September 16, 2019

Re: North Carolina Department of Environmental Quality Comment on the draft Environmental Impact Statement (DEIS) for the Southgate Project, proposed by Mountain Valley Pipeline, LLC: Docket Number: CP19-14-000.

### DEIS Comments from NCDEQ Division of Energy, Minerals, and Land Resources (DEMLR)

### **DEIS Comments from NCDEQ Division of Water Resources (DWR)**

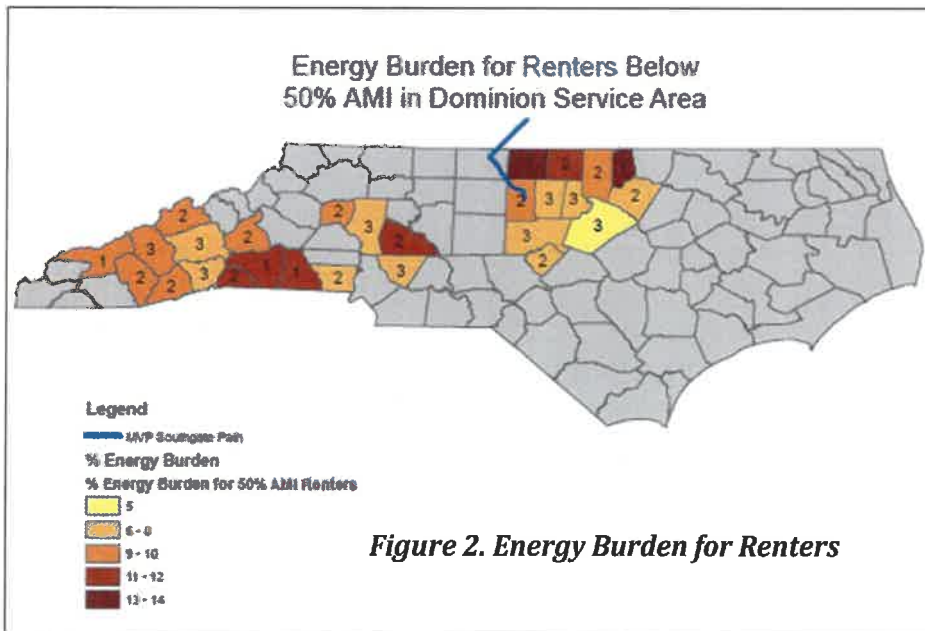
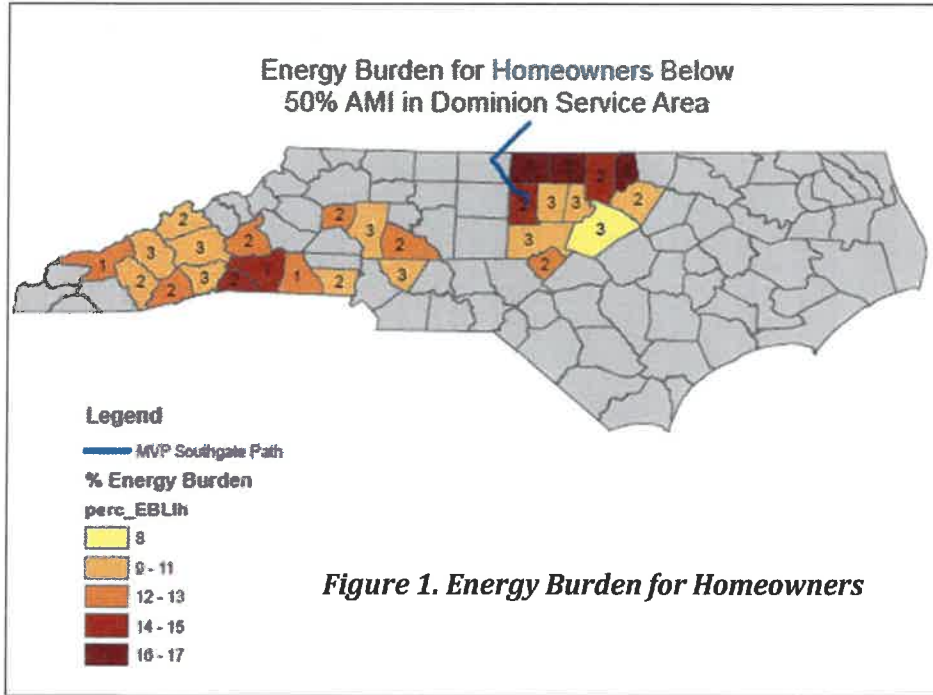
on the counties identified by the Department of Commerce tier ranking.<sup>42</sup> This evaluation of the energy burden (using the percentage of annual income that energy accounts for in AMI households) was performed for both low income homeowners and low income renters as displayed in Figures 1 and 2 below.

The energy burden for AMI households in the Dominion Energy service area ranges from 5% (for renters in Wake County) to more than 16% (for homeowners in Person County). To put this in context, the U.S. Department of Health and Human Services classifies energy burden at an amount greater than 6% of a household's annual income as "unaffordable." Based on this definition, each of the counties' lowest earning households (with the exception of Wake County renters) in the Dominion Energy service area have an "unaffordable" average energy burden. Furthermore, these initial evaluations demonstrate that the socioeconomic impacts of the Project potentially extend well beyond the physical route of the pipeline.

We ask that FERC use this data to fully evaluate the imposition of pass-through costs for the construction, operation, and ROI for the Project on these populations. This is fundamental information that the Commission must incorporate in its determination of need for the Project. North Carolinians residing or conducting business in Dominion Energy service territory should not be left to shoulder increased energy rates for this Project for which there is no demonstrable demand.
